Access Compliance Report

Public Rights-of-Way

Intersection ID: 23910	Main Street: KNIGHTSWOOD_DR	Cross Street: WINDYRUSH_RD	Location: SE
ADA ID: 8F70C53165E9	Ramp Type: Perpendicular Diagonal	Initial Pass/Fail: Fail	Overall Compliance: No
		Severity Score: 8.75

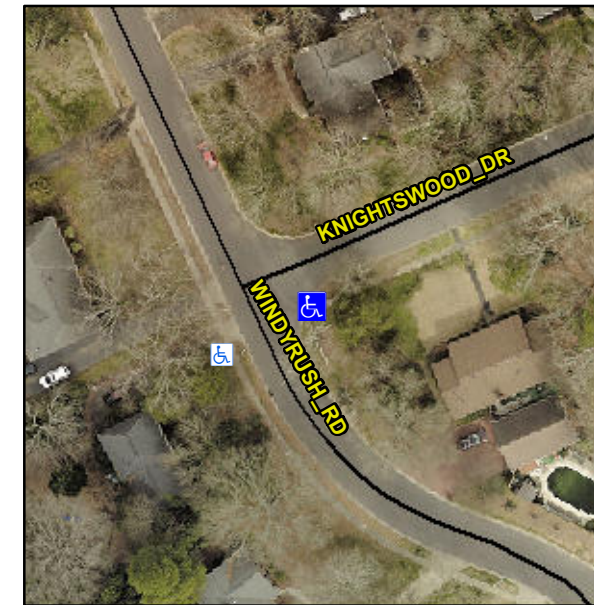
Not Found, R304.5.1

Remove & Replace Curb Ramp With Two New Directional Ramps or Equivalent.
